NOT FOR FABRICATION OR POWER-UP; REJECTED CANDIDATE. Pump diode polarity and panel capacitor endpoints require correction and independent manufacturer-diagram review.

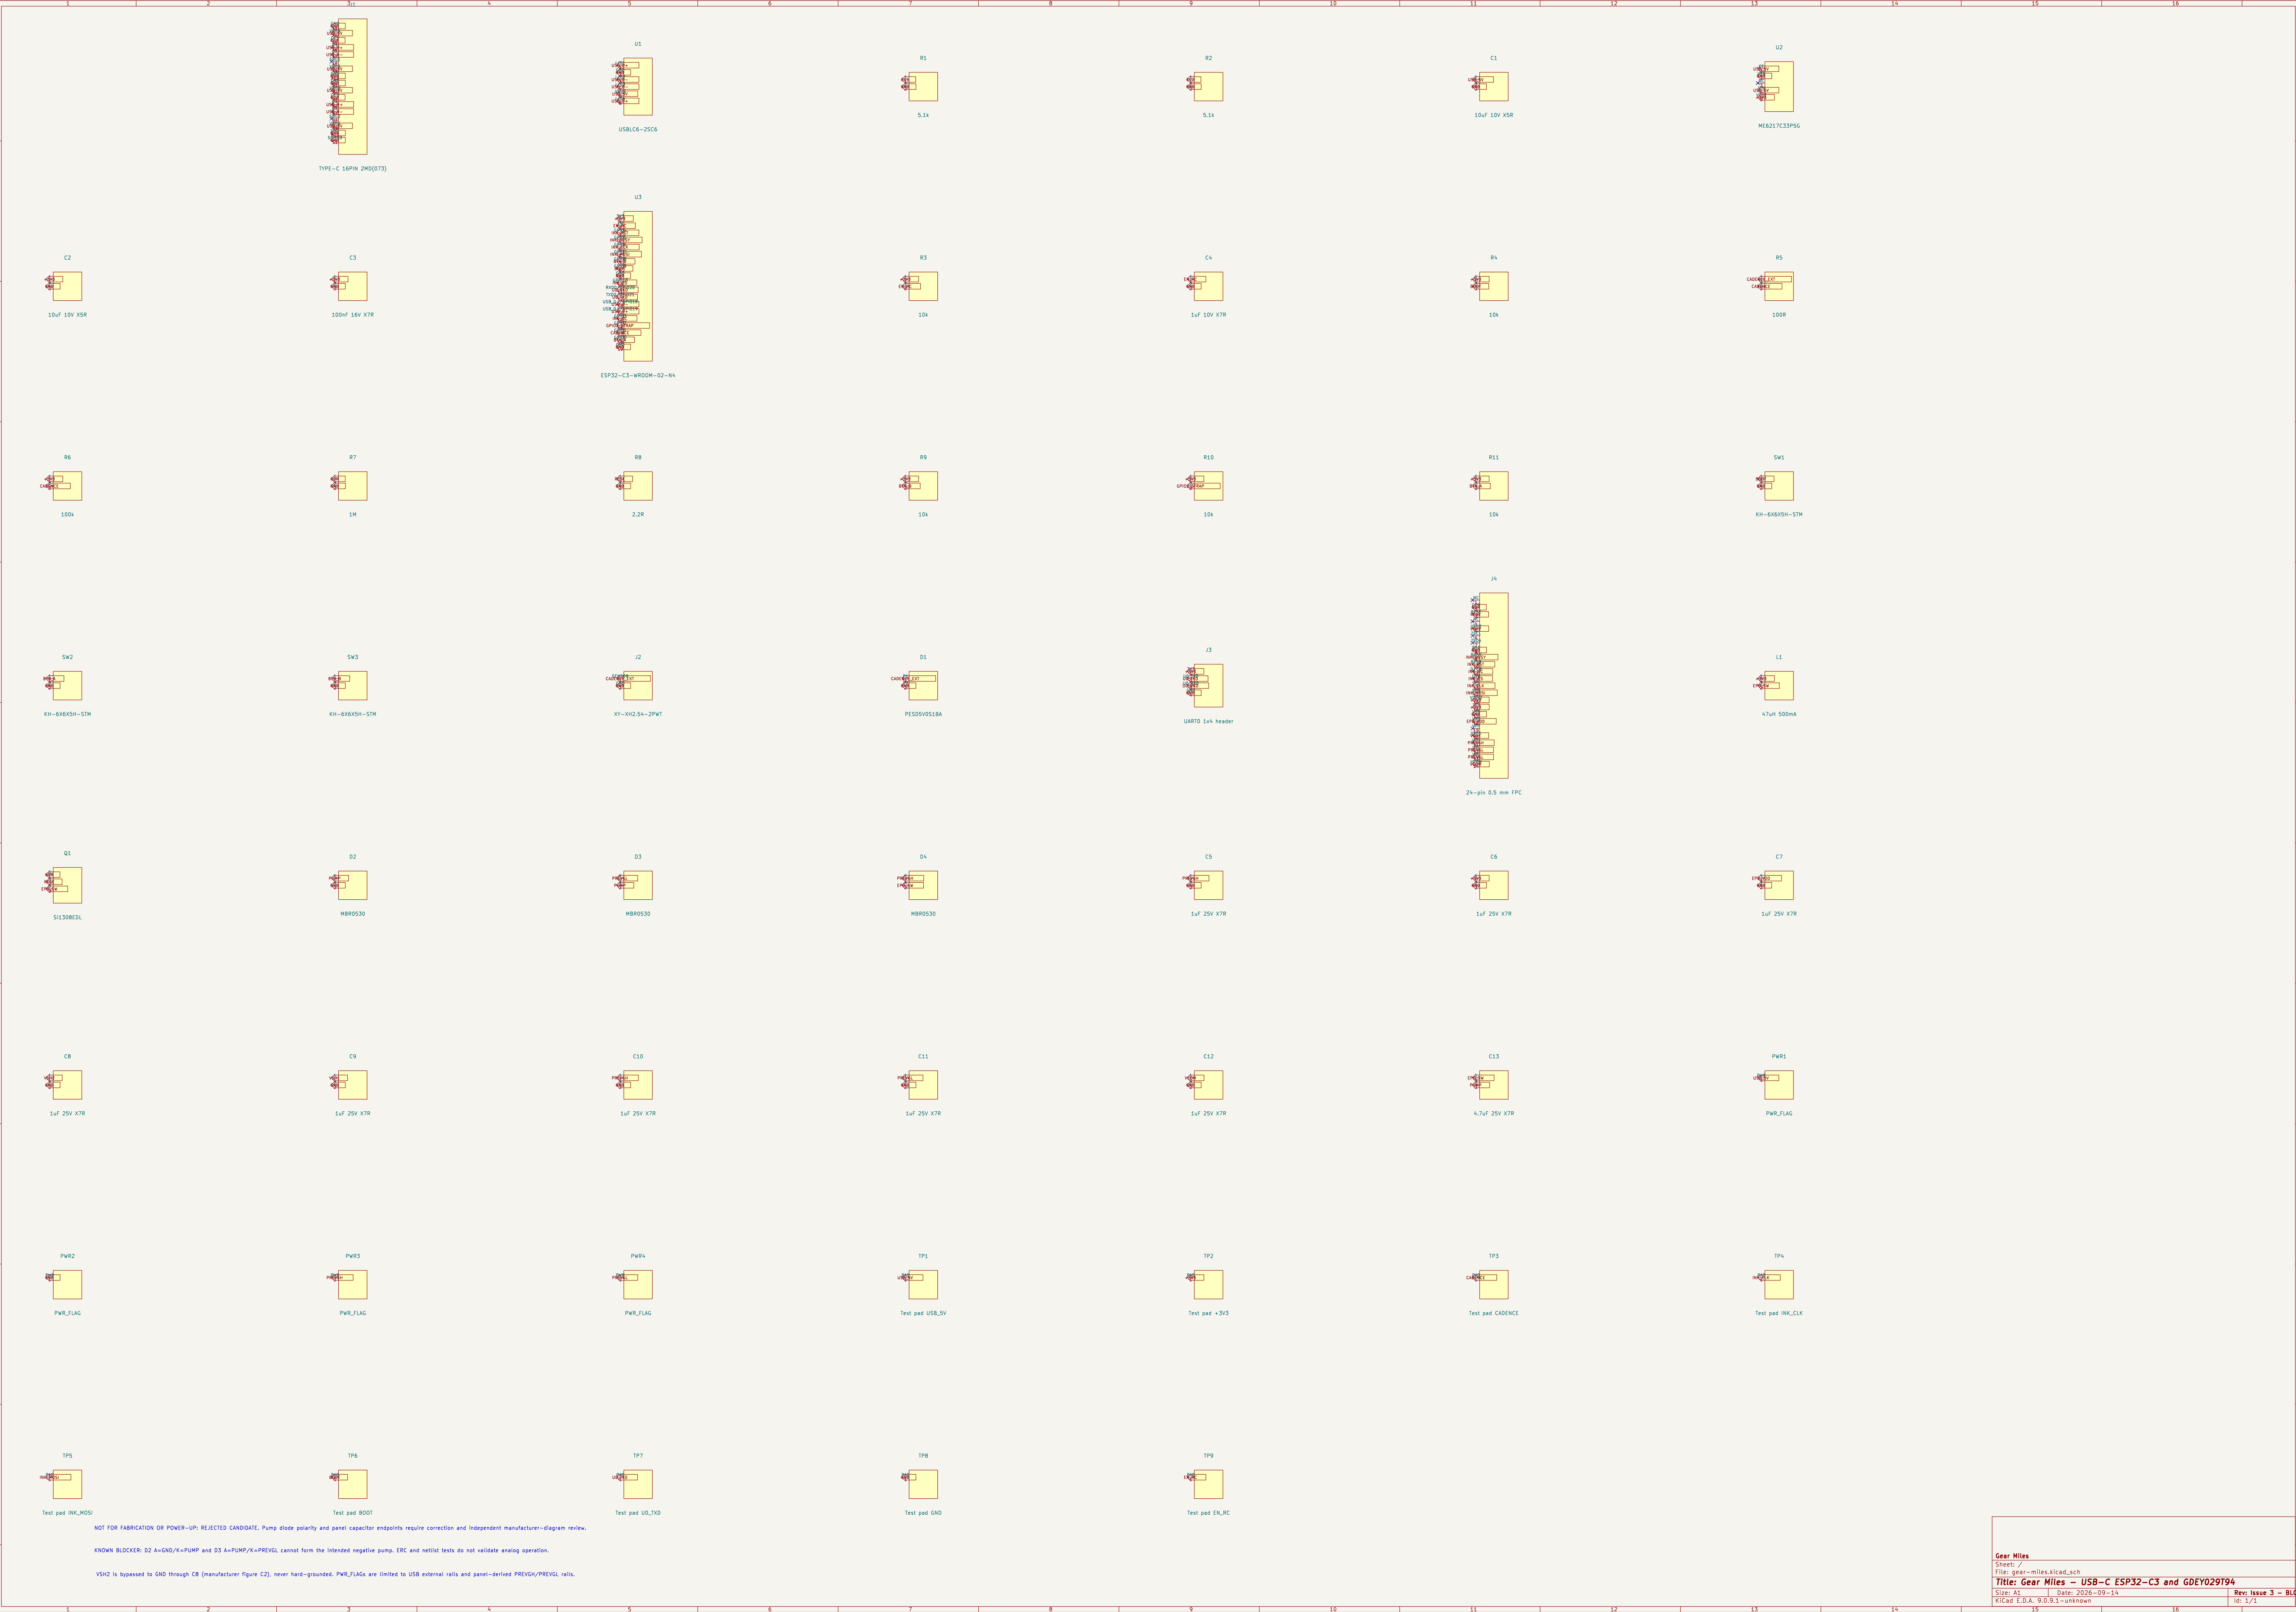
KNOWN BLOCKER: D2 A=CAPD/K=PUMP and D3 A=PUMP/K=PREVGL cannot form the intended negative pump. ERC and netlist tests do not validate analog operation.

VSHQ2 is bypassed to GND through CB (manufacturer figure C2); never hard-grounded. PWR_FLAGS are limited to USB external rails and panel-derived PREVGH/PREVGL rails.
